2. CONTRAST OF MISCELLANEOUS PARTS

2.1 CONTRAST TABLE

(1) CDJ-2000 and CDJ-2000/2 are constructed the same except for the following:

9.7 TM ASSY-S

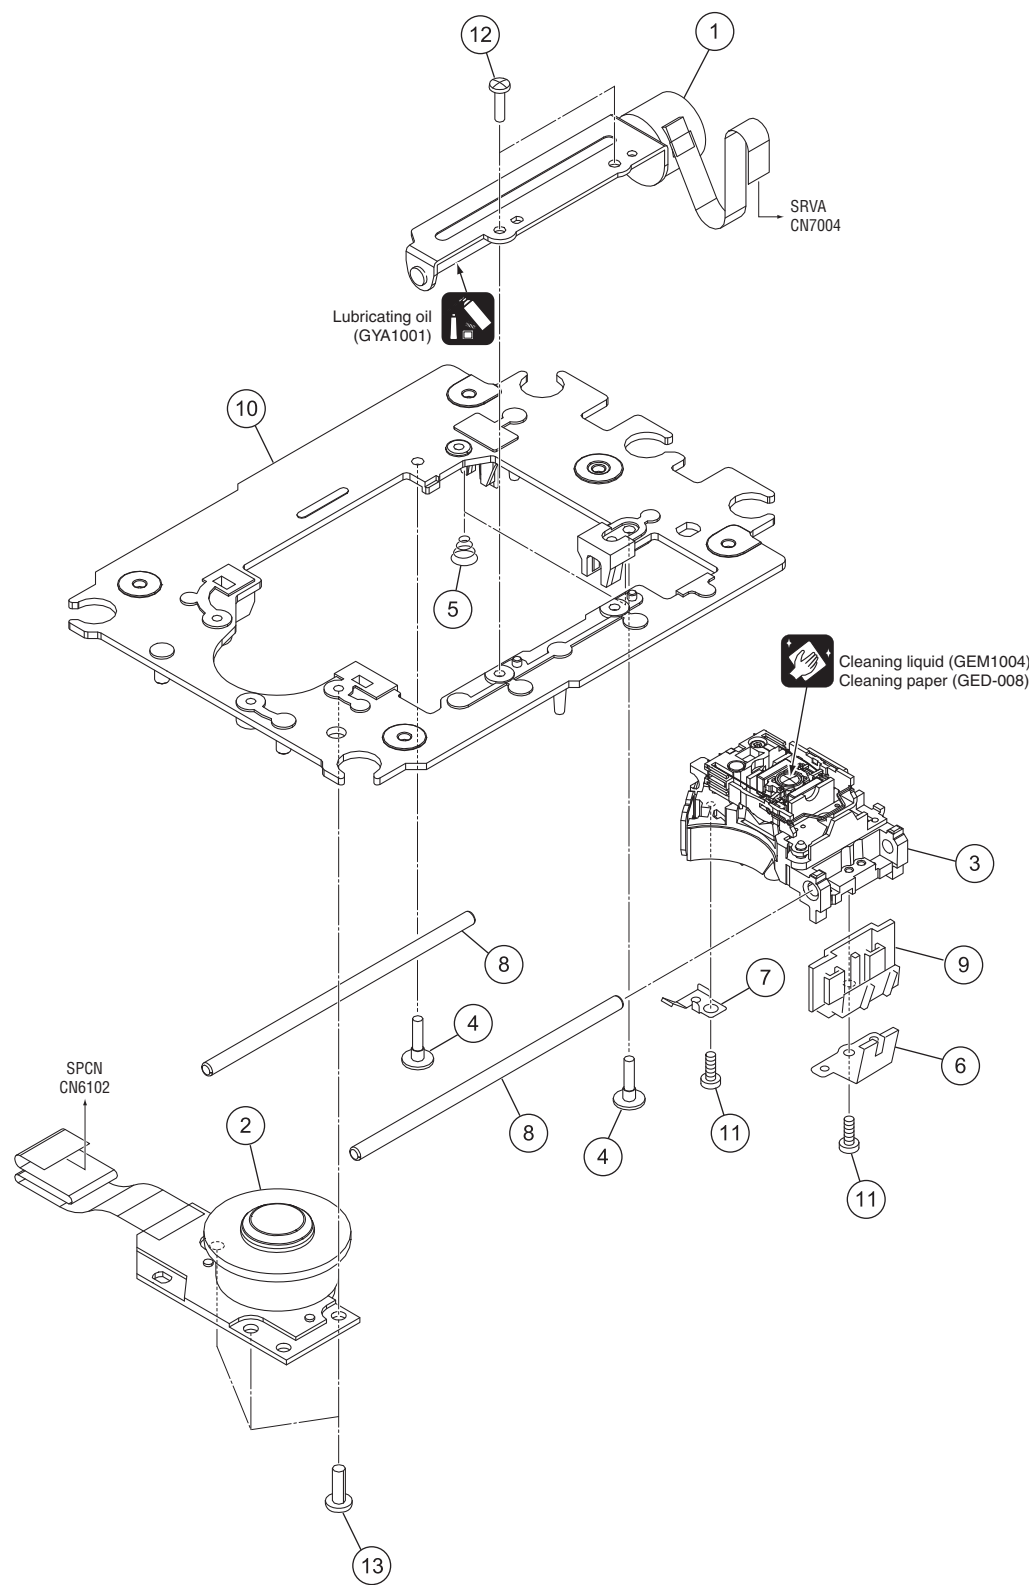
Changing the constants for the parts of the MAIN and JACB Assys

With a modification of the LCD section, the constants for the parts of the MAIN and JACB Assy, have been changed for improvement of the sound quality.

Mark	No.	Description	Part No.
MAIN Assy : DWG1660			
<u>RESISTORS</u>			
R	570	RS1/16SS332J =>	RS1/16SS222J
R	571	RS1/16SS332J =>	RS1/16SS222J
R	572	RS1/16SS332J =>	RS1/16SS222J
R	573	RS1/16SS332J =>	RS1/16SS222J
<u>CAPACITORS</u>			
C	3093	CEHVAW101M16 =>	CCH1565
JACB Assy : DWX2988			
<u>CAPACITORS</u>			
C	9401	CEHAZL220M50 =>	CEHAZL101M25
C	9404	CEHAZL220M50 =>	CEHAZL101M25
